Petition Number: 2023-039

From: Jake Carpenter, PE Reviewer: Isaiah Washington

Date	Description		
7-26-23	First Review (IW)		
11-27-23	Second Review (DR)

Transportation Summary

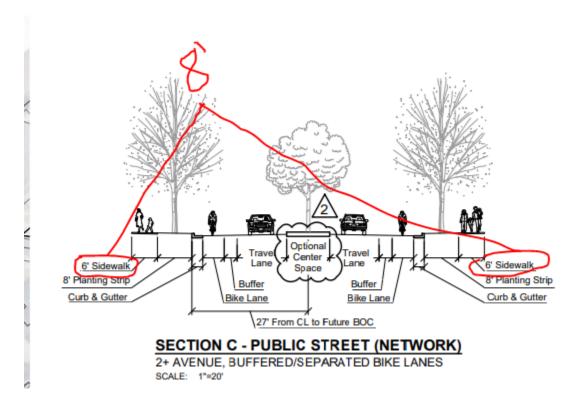
Clarifying comment 11.27.23: ROW dedication for Old Providence should be 43' based on the 8' sidewalk on Old Providence Road instead of the 6' sidewalk dimension shown on Section C.

8. The proposed dwelling units exceeds 12 per acre. Per Chapter 20 Subdivision ordinance, revise site plan and conditional note(s) to commit to construct an 8-foot planting strip, and 8-foot sidewalk along Old Providence Road. The wider sidewalk also meets the Charlotte WALKS Policy.

New Comment 11.27.23: Section C public street network sidewalk width does not match the conditional note. Revise Section C to have an 8' sidewalk like the conditional notes for the Old Providence Road section.
